PZ&B Staff Combination Memorandum: Landmarks Preservation Commission and Town Council

SUBJECT: ZON-23-106 (COA-23-038) 318 AUSTRALIAN AVE (COMBO)

MEETING: NOVEMBER 17, 2023 LPC
DECEMBER 13, 2023 TC

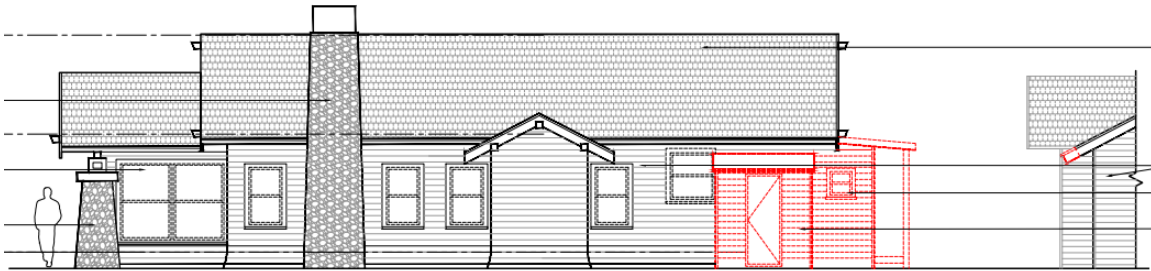
The application requests to replace the structure's windows and doors with new impact-rated products, predominately divided lite hung windows and glazed divided lite doors. Additionally, the existing asphalt shingle roof is proposed to be replaced with Owen's Corning dimensional asphalt shingles in "Terra Cotta". The existing wood clapboard siding is to be repaired and replaced in-kind only where rot or deterioration has rendered the material beyond repair. The existing stone cladding on the structure's chimney and front porch columns are also to be retained and preserved. The applicant has included demolition floor plans, roof plans, and elevations on Sheets A-001 – A-008 of the architectural plan sets. In addition to the removal of windows, doors, and roof cladding, the application requests to demolish a rear enclosed porch and attached storage shed located on the west side of the property. Per the documentation provided, the request does not propose to demolish more than 50% of any elevation or roof structure. The application requests to replace the rear enclosed porch with a new enclosed breakfast room, which will be connected to the guest house with a new pergola structure. Existing and proposed West Elevations (Sheet A-006) are provided below and identify the areas of demolition in red and the proposed enclosed addition and pergola connector.

The existing property currently maintains a nonconforming lot coverage of 34.3%, where 30% is permitted for single-family residences in the R-C district. The proposed enclosed addition is slightly larger than the area proposed to be demolished and the new pergola connector also counts towards increased lot coverage. As such, the applicants have requested **Variance 2**, to permit lot coverage at 35.74% in lieu of the 34.3% existing and the 30% maximum permitted. The variance amount is as follows:
